CPC - ALTON RD
1801 ALTON RD.
MIAMI BEACH, FL 33139

Re:	PC #:	B1103915
	Commercial Plan Review Dated:	8.17.11
	Project Name:	Chase – CPC Alton
	Address:	1801 Alton Road
	Occupancy:	B

(Revision 3, PLAN REVIEW COMMENTS, dated 04-22-2013)

In response to the current City of Miami Beach building review comments, the following items are enclosed for your review and approval of the above referenced project:

ELEVATION AT FRONT OF TELLER LINE SCALE 1/4" = 1'-0" 1

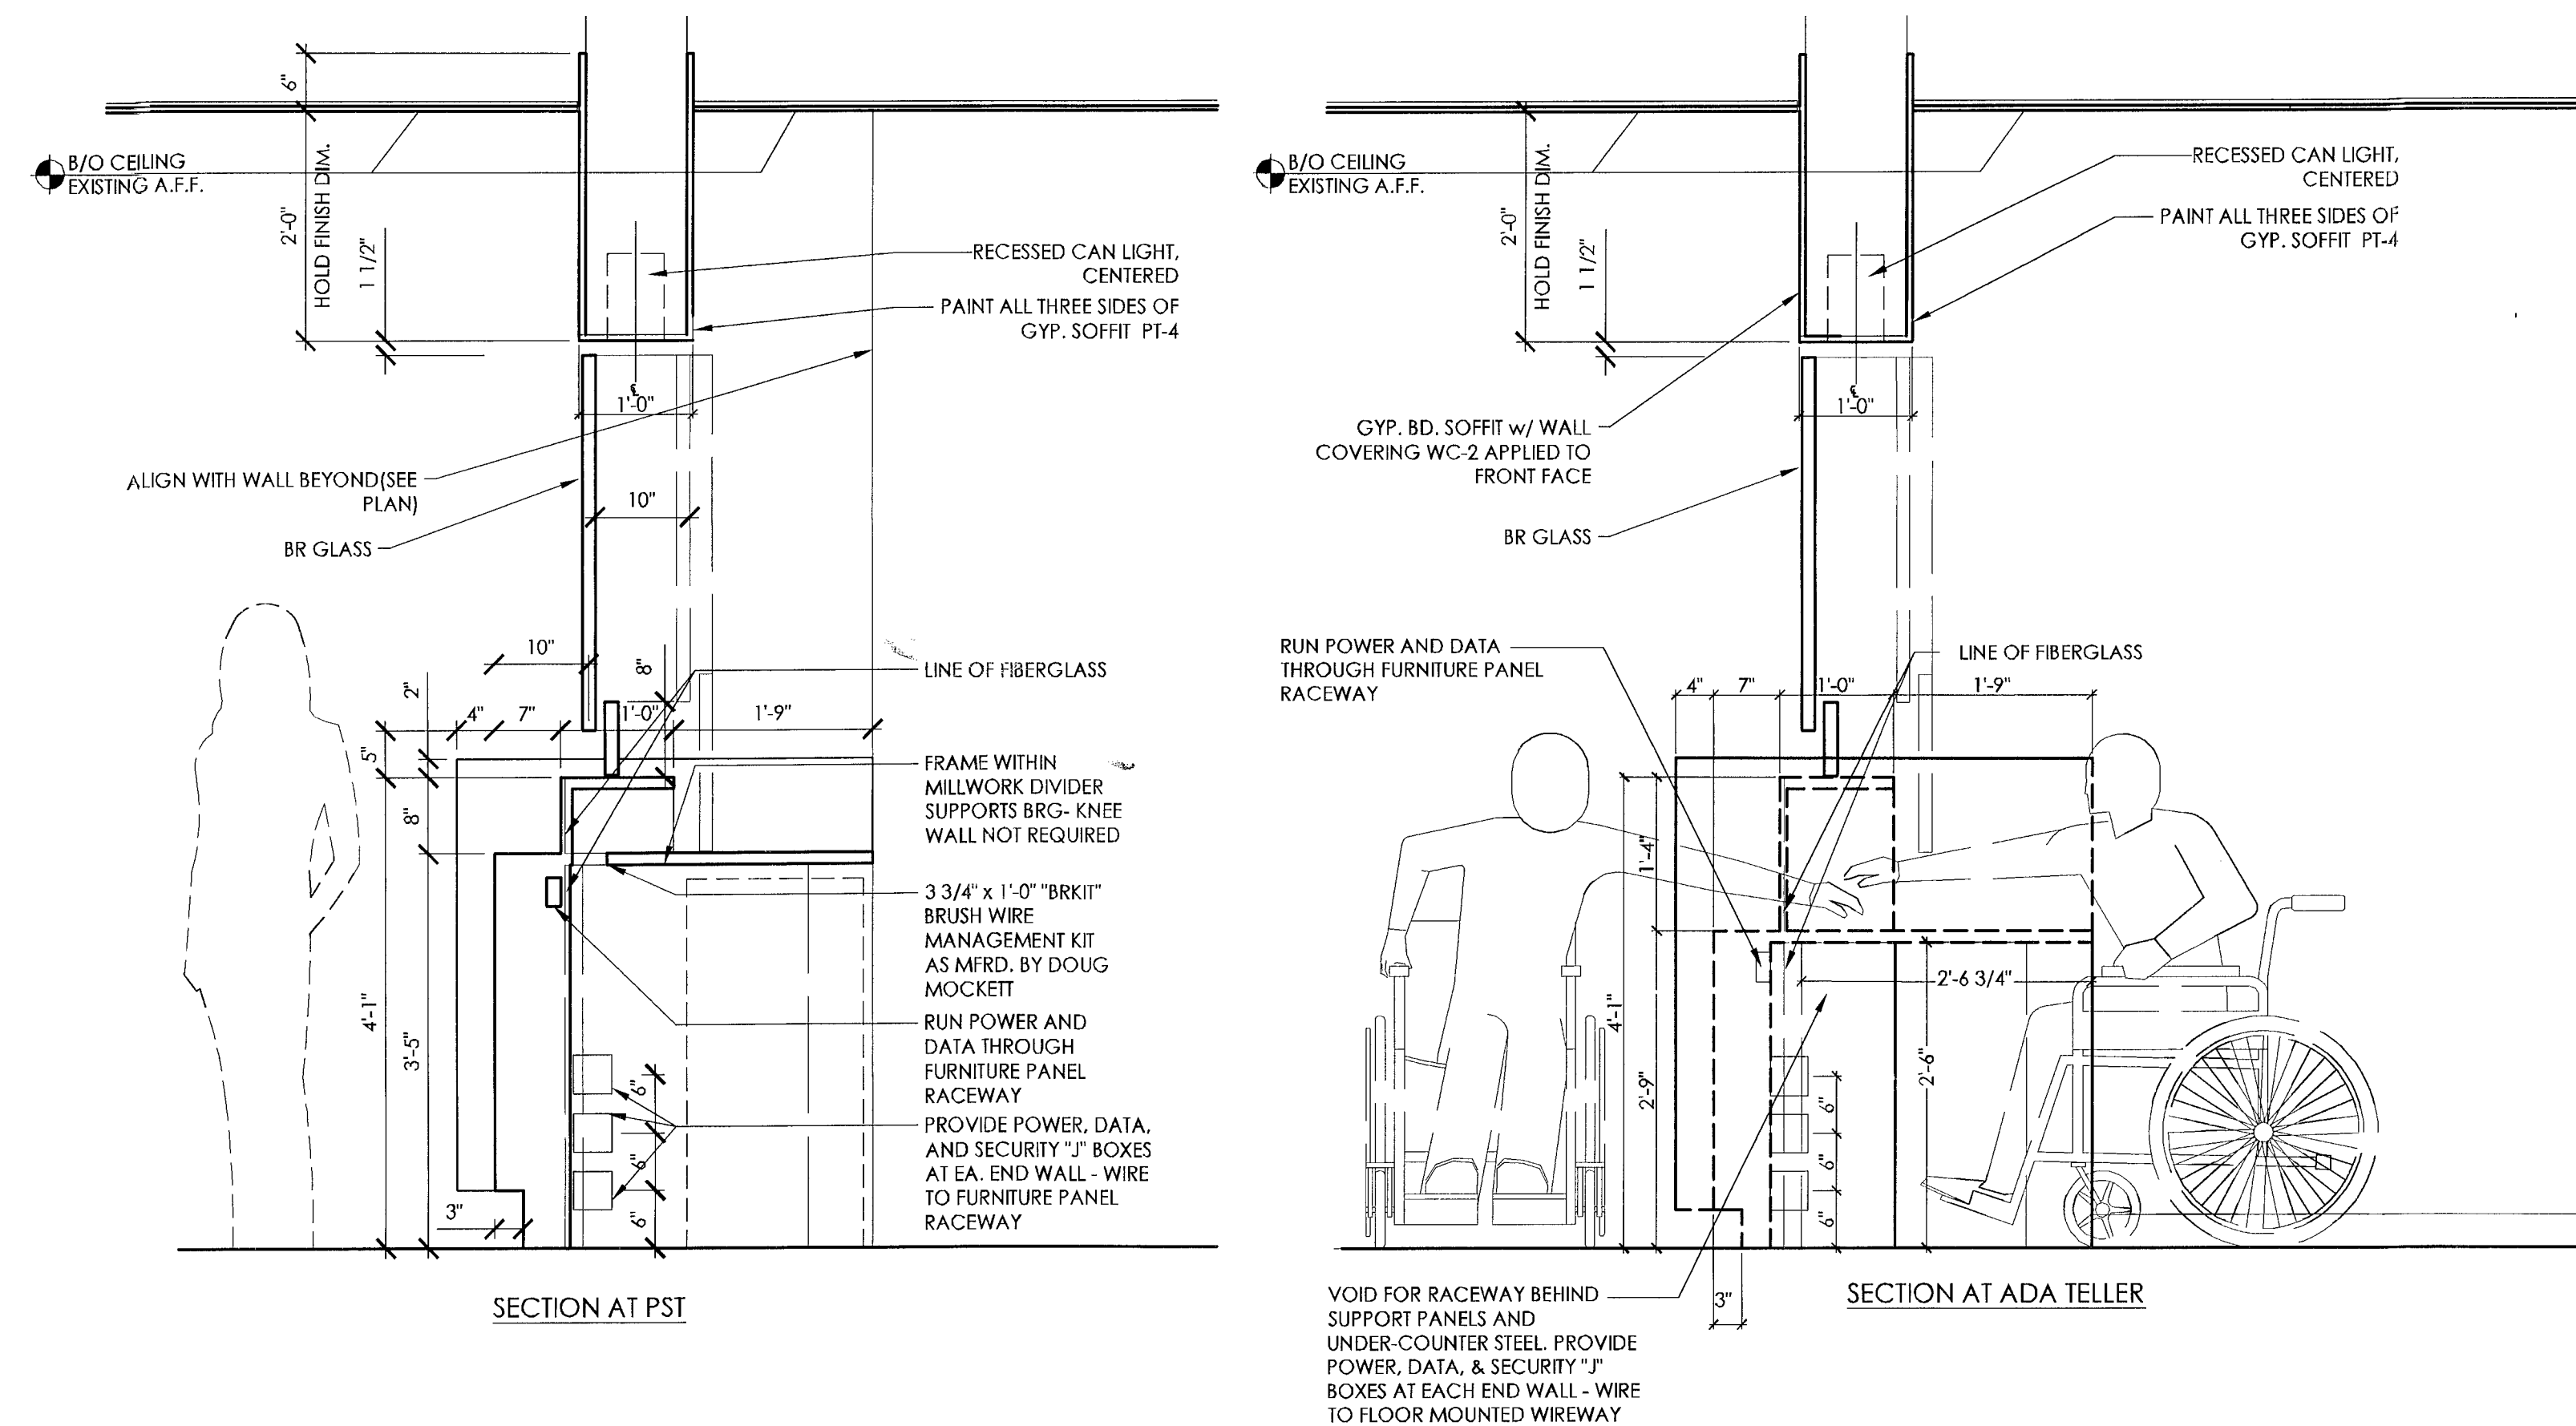
8. **Elevation 1/A5.1: Provide accessibility sign to comply with FAC §216.**

9. **Elevation 1/A5.1: Provide length of accessible teller counter, 36" minimum, to comply with FAC §904.4.**

RESPONSE: Please refer to attached revised sheet A5.1, detail 1, for requested detail.

RESPONSE: Please refer to attached revised sheet A1.2, detail 2 for requested information.

SECTIONS AT TELLER LINE SCALE 3/4" = 1'-0" 5

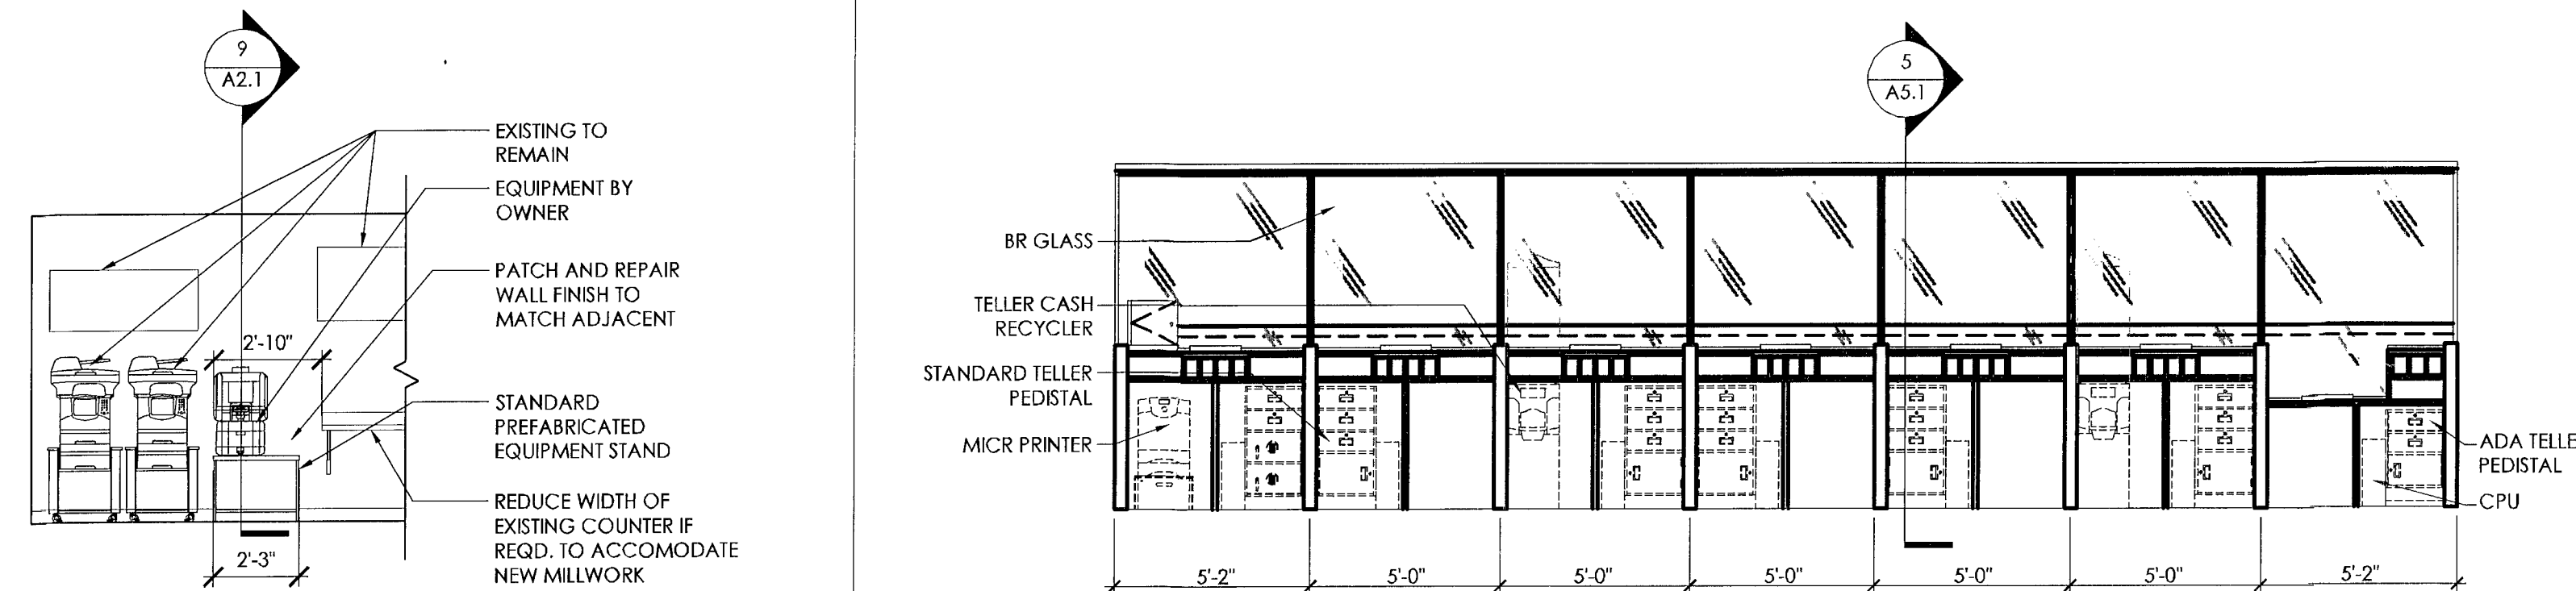
10. **Section 5/A5.1: Provide bottom of counter knee clearance dimension, 27" minimum, per FAC §306.3.**

11. Section 5/A5.1: Provide 25" maximum reach dimension, suggest reduce 1'-9" dimension to 1'-1" to comply with FAC §308.2.

RESPONSE: Please refer to attached revised sheet A5.1, detail 5, for requested information.

As discussed, the bullet-resistant teller line is a pre-manufactured item, and cannot be modified. However, the configuration of the bullet-resistant glass includes a pass-through for transactions. The maximum required reach on the public side (side reach) is 24" into the pass-through. The maximum required reach on the employee side (forward reach) is 25". As the total depth of the transaction counter is 44", the public and employee reaches overlap by approximately 5" within the pass-through.

SCHEMATIC CEILING SECTION SCALE 1/2" = 1'-0" 8

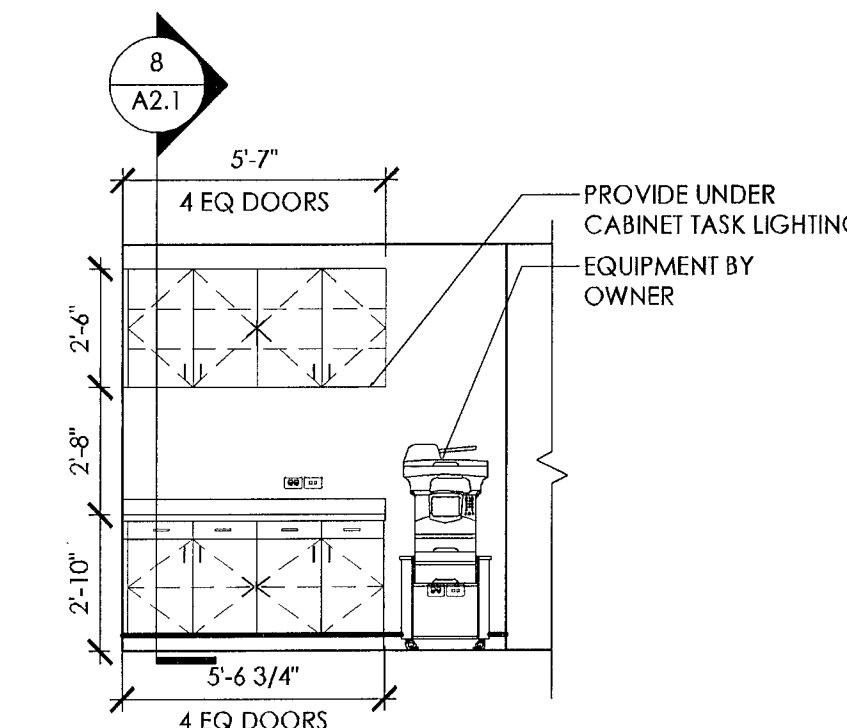
2. **Sheet A0.0: Provide number of stories of building. Clarify if floor ceiling assembly over work area is a fire rated separation for occupancy above. If so, on plans provide a cross section and a UL detail (or equal) for the fire rated floor-ceiling assembly in compliance with FBC chapter 7.**

RESPONSE: The existing building has two stories. As per telephone discussion between Mr. Schaad (City of Miami Beach) and Caleb Janus (BDG Architects) on March 25, 2013, on-site investigations have been made, which indicate that the construction of the floor/ceiling assembly is poured concrete slab on poured concrete beams. As discussed, it is not possible to determine the exact nature of the materials and thickness of the structure. However, the existing floor / ceiling assembly is not being altered or affected in any way by the proposed renovation. Please refer to attached revised sheets A0.0 & A5.1 detail 8, for a schematic section of the existing condition as requested.

EXISTING CHECK DESK SCALE 3/8" = 1'-0" 9

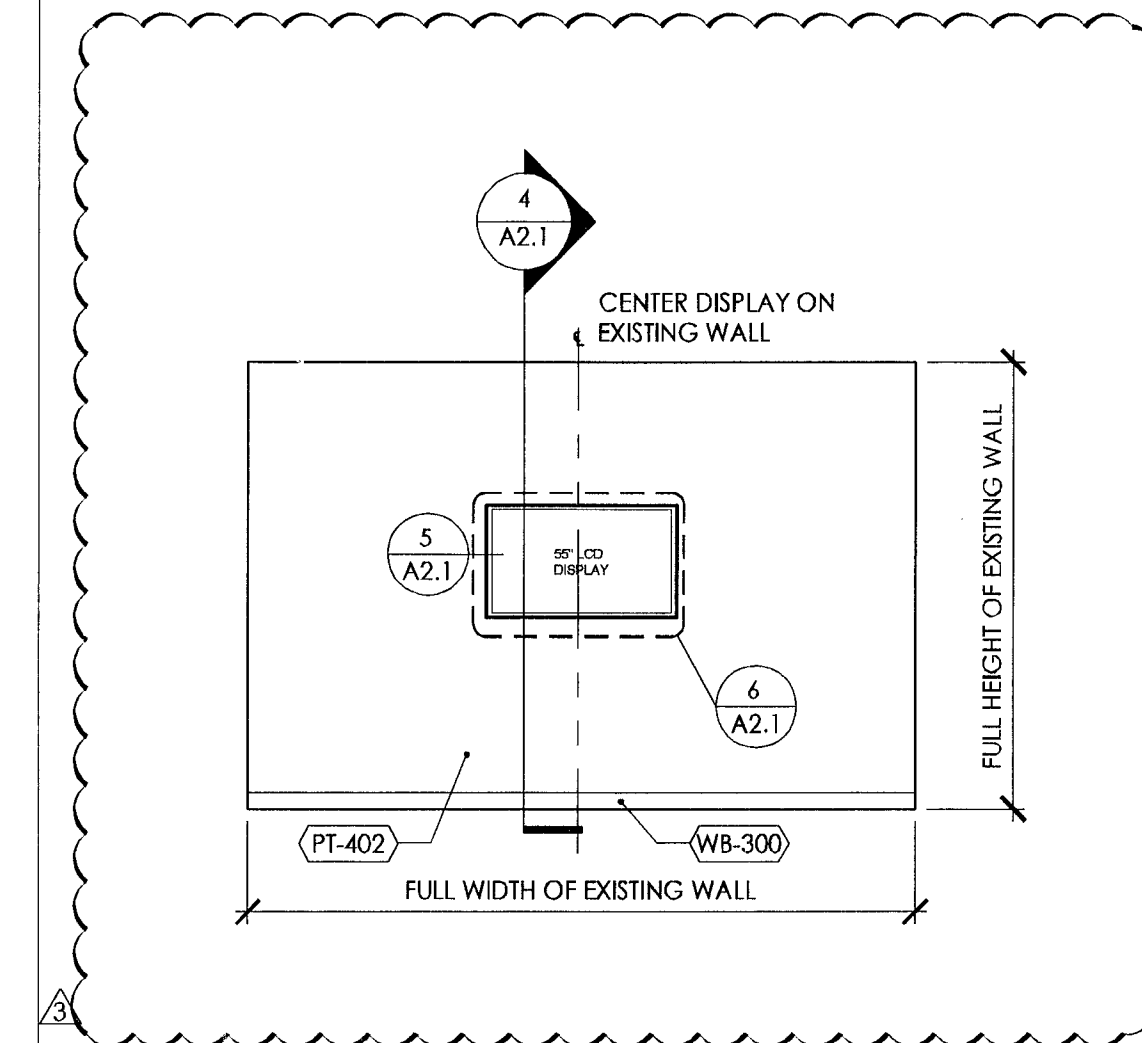
7. **Plan 2/A1.2: Check desk FP09: Provide check writing desk accessible details to comply with FAC §904.3.3.**

RESPONSE: Please refer to attached revised sheet A5.1, detail 9, for accessibility assessment of existing check desk to be relocated.
